SUBJECT: Responds to RAI re second ten yr interval ISI program relief
 2ISI-15 for exam Category C-G pump casing welds.

Subject: **WNP-2, OPERATING LICENSE NPF-21
REQUEST FOR ADDITIONAL INFORMATION REGARDING SECOND
10-YEAR INTERVAL INSERVICE INSPECTION PROGRAM RELIEF
2ISI-15**

RESUBMITTAL OF RELIEF REQUEST 2ISI-15

WELD AND COMPONENT
IDENTIFICATION DIAGRAM
HPCS-P-1 (E22-C001)

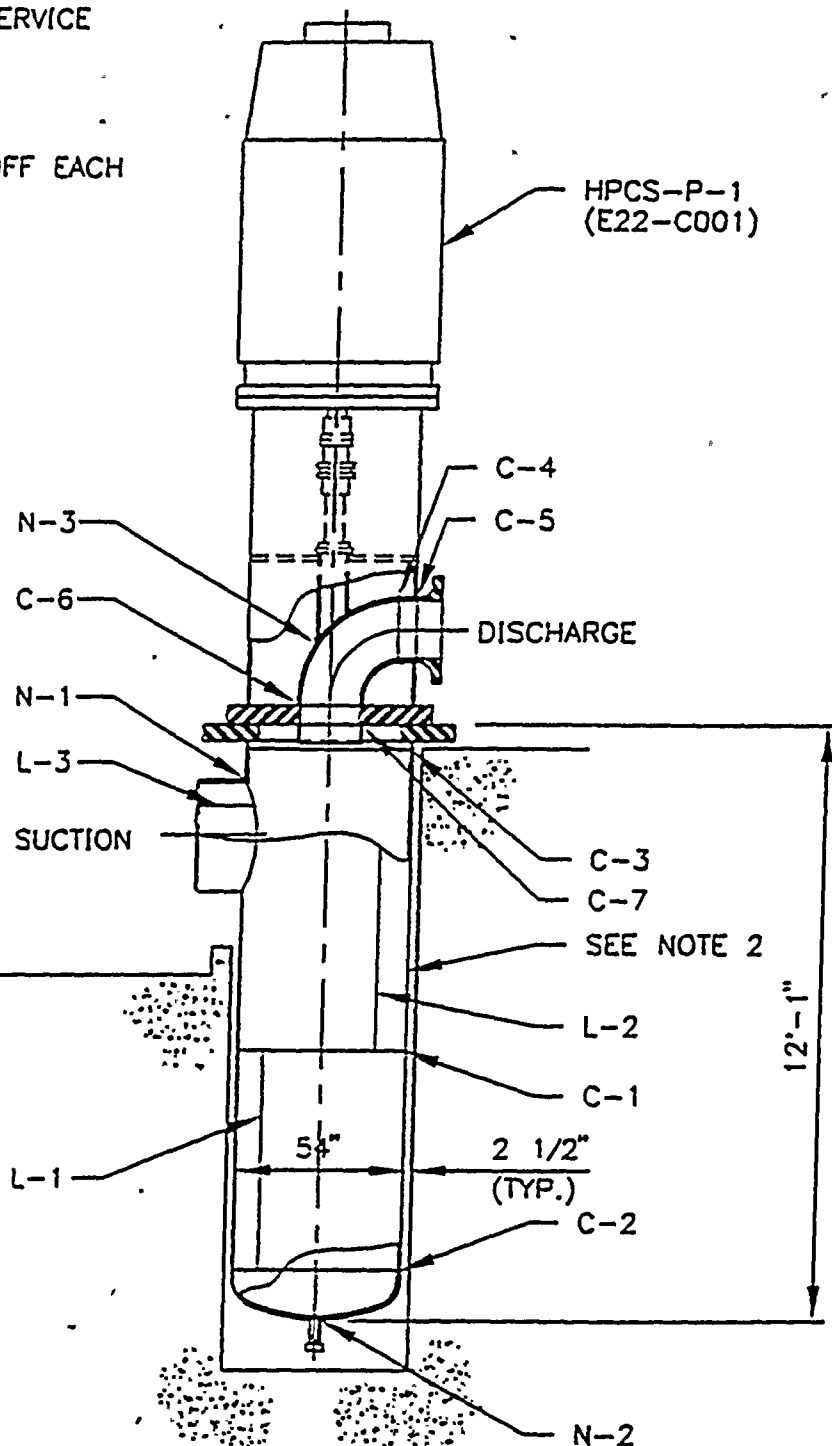
Based on a review of the sketches, it appears that a portion of some of the subject welds may be accessible from the outside surface. Is this the case and, if so, has the licensee performed any partial examinations from the outside surface?

C-4, C-5, C-6 and N-3

HPCS-P-1

Upon further review, it has been confirmed that the discharge welds listed below, or a portion of them, are accessible for outside surface examination:

The degree of accessibility depends on the access available for removing the protective coating (paint) to perform the examination. These welds are within the shroud between the pump casing and the pump motor. Inside this shroud are the seal cooler piping and the pump shaft. The two openings in the shroud, 180 degrees apart, provide the access to these welds. The seal cooler piping, the pump shaft and the shroud openings partially obstruct the process of removing the protective coating so an examination can be performed.

HPCS-P-1C-1	PMP CAS/CIR WLD	C6.10	HPCS-206-1
HPCS-P-1C-2	PMP CAS/CIR WLD	C6.10	HPCS-206-1
HPCS-P-1C-3	PMP CAS/CIR WLD	C6.10	HPCS-206-1
HPCS-P-1C-7	PMP CAS/CIR WLD	C6.10	HPCS-206-1
HPCS-P-1N-2	PMP NOZZLE WELD	C6.10	HPCS-206-1
HPCS-P-1L-1	PMPCAS/LONG.WLD	C6.10	HPCS-206-1
HPCS-P-1L-2	PMPCAS/LONG.WLD	C6.10	HPCS-206-1
HPCS-P-1L-3	PMPCAS/LONG.WLD	C6.10	HPCS-206-1

HPCS-P-1C-5 ⁷	PMP CAS/CIR WLD	C6.10	HPCS-206-1
HPCS-P-1N-1 ⁸	PMP NOZZLE WELD	C6.10	HPCS-206-1

WELD AND COMPONENT
IDENTIFICATION DIAGRAM
LPCS-P-1 (E21-P001)

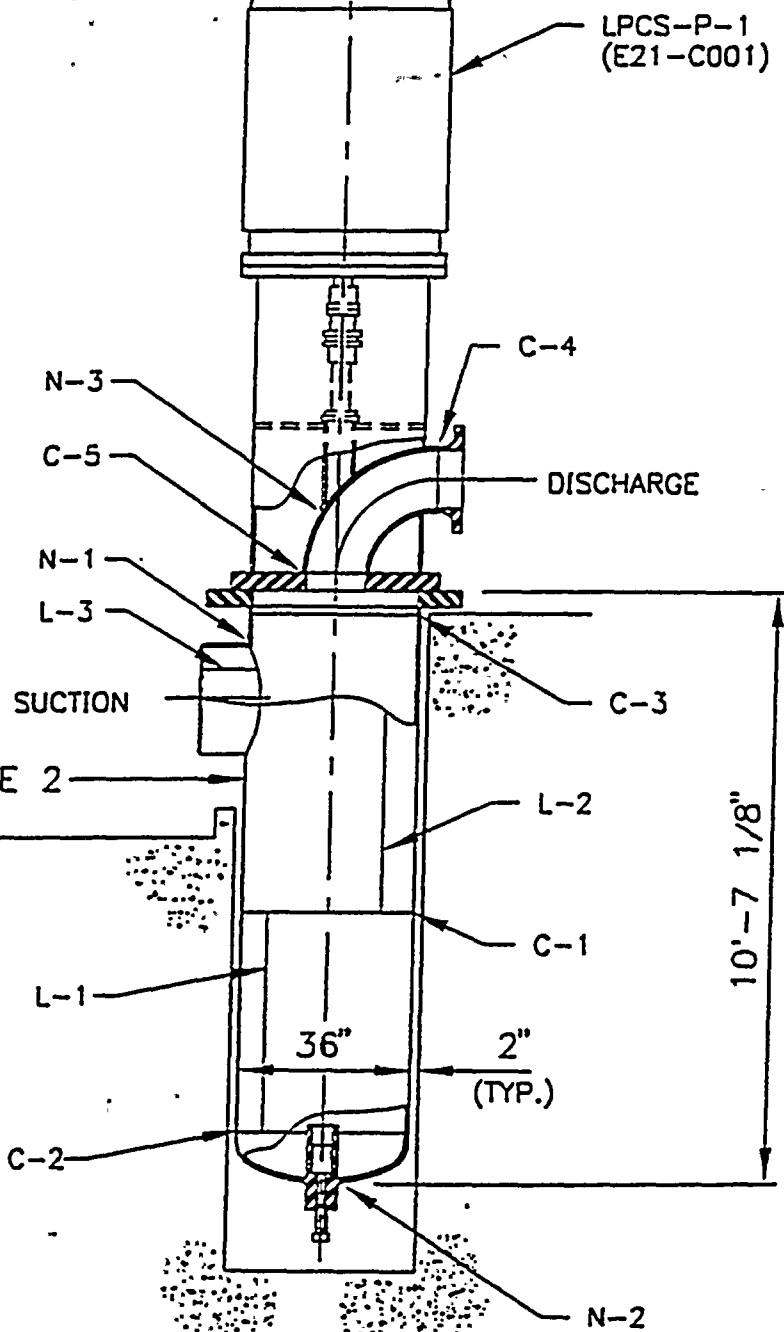
C-4, C-5, and N-3

LPCS-P-1, RHR-P-2A, RHR-P-2B, RHR-P-2C

LPCS-P-1C-1	PMP CAS/CIR WLD	C6.10	LPCS-208-1
LPCS-P-1C-2	PMP CAS/CIR WLD	C6.10	LPCS-208-1
LPCS-P-1C-3	PMP CAS/CIR WLD	C6.10	LPCS-208-1
LPCS-P-1N-2	PMP NOZZLE WELD	C6.10	LPCS-208-1
LPCS-P-1L-1	PMPCAS/LONG.WLD	C6.10	LPCS-208-1
LPCS-P-1L-2	PMPCAS/LONG.WLD	C6.10	LPCS-208-1
LPCS-P-1L-3	PMPCAS/LONG.WLD	C6.10	LPCS-208-1

LPCS-P-1N-1 ⁹	PMP NOZZLE WELD	C6.10	LPCS-208-1
--------------------------	-----------------	-------	------------

Figure 3

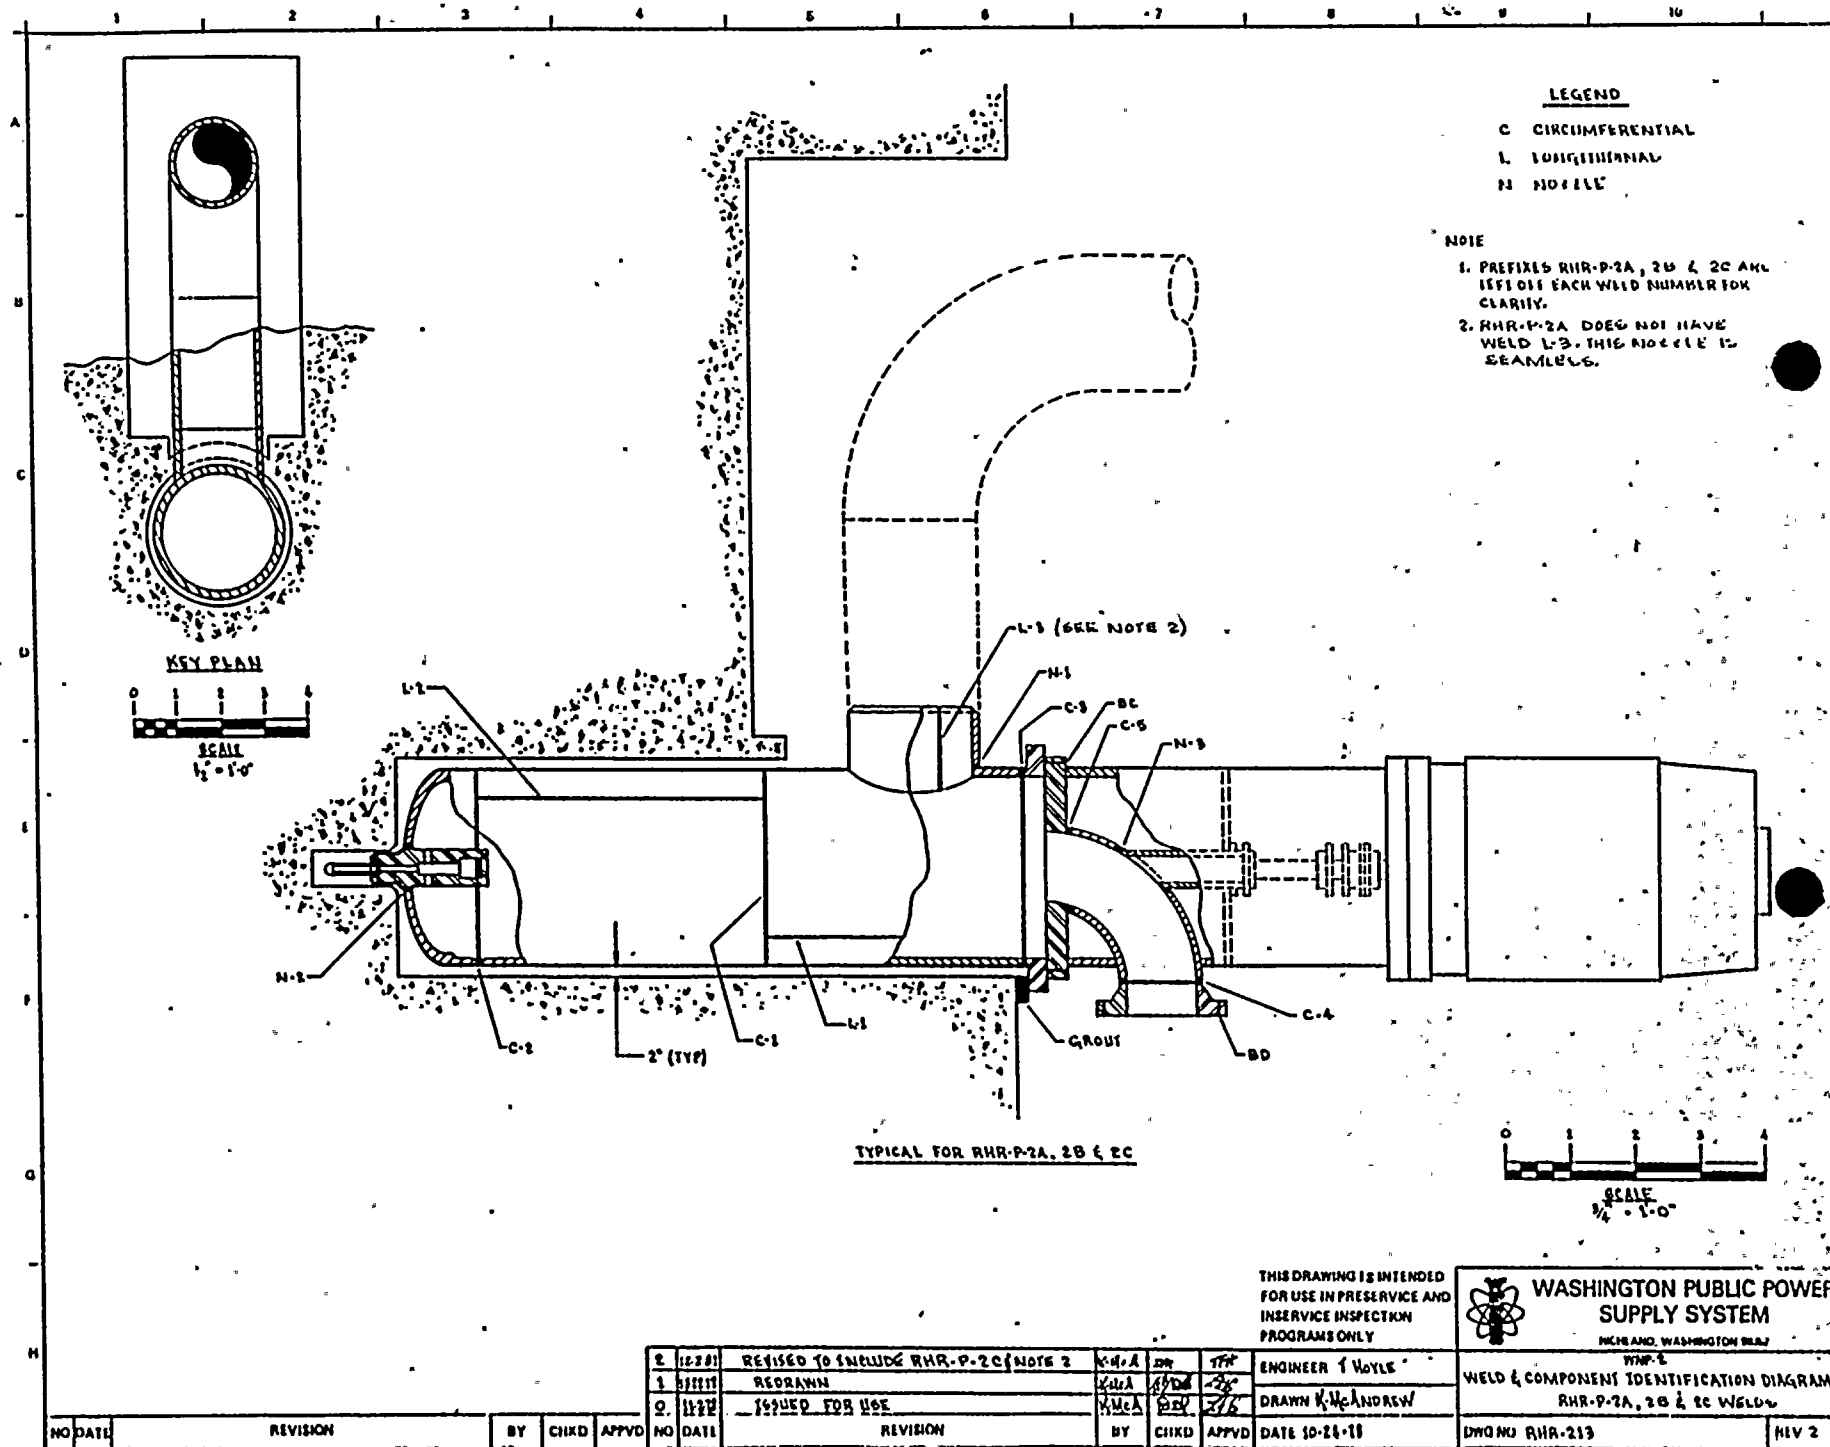
Two welds on the suction side of the pumps, L-3 and N-1, have limited accessibility due to the pump pit and grouting around these welds. L-3 is not accessible from the outside. During the present refueling outage the N-1 weld for one RHR pump will receive a partial inspection due to only a small area being accessible from the top and bottom.

As stated in the response to question 2, the discharge welds for the HPCS and LPCS pumps were inadvertently included with the suction side welds and therefore were not examined during the first inspection interval. For the RHR pumps the discharge welds were inadvertently classified as inaccessible. In addition, the N-1 suction welds for the RHR pumps were deemed inaccessible. Corrective action is in progress to examine the discharge side welds of the HPCS and LPCS pumps, and one RHR pump during the current refueling outage. In addition, one suction side weld on one RHR pump will also be examined. These examinations will satisfy the examinations required for the First 10-Year Inservice Inspection Program Plan. In addition, the RHR pump examination will be credited for the first inspection period of the Second 10-Year Inservice Inspection Program Plan.

RHR-P-2BC-1	PMP CAS/CIR WLD	C6.10	RHR-213
RHR-P-2BC-2	PMP CAS/CIR WLD	C6.10	RHR-213
RHR-P-2BC-3	PMP CAS/CIR WLD	C6.10	RHR-213
RHR-P-2BN-2	PMP NOZZLE WELD	C6.10	RHR-213
RHR-P-2BL-1	PMPCAS/LONG.WLD	C6.10	RHR-213
RHR-P-2BL-2	PMPCAS/LONG.WLD	C6.10	RHR-213
RHR-P-2BL-3	PMPCAS/LONG.WLD	C6.10	RHR-213

RHR-P-2BN-1 ⁵	PMP NOZZLE WELD	C6.10	RHR-213
--------------------------	-----------------	-------	---------
